## Change Pollin AVR-Net-IO board to 3.3V

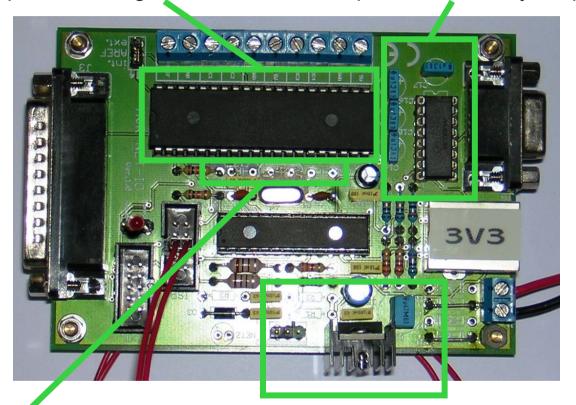
Replace IC5 by ATMEGA644P -Use a 3.3V capable ATmega

Replace IC4 by MAX3232 Replace C14-17 by 0.1µF capacitors

Use 3.3V compliant crystal frequency Or unsolder crystal and connect IC5 pin 13 (XTAL1) with

Replace IC1 by LM3940-3.3 Replace C3 by 0.47µF capacitor Short IC2 pin 2 and 3 IC3 pin 3 (CLKOUT – default 6.25MHz) Short D1 and D4 to use a 5V power supply
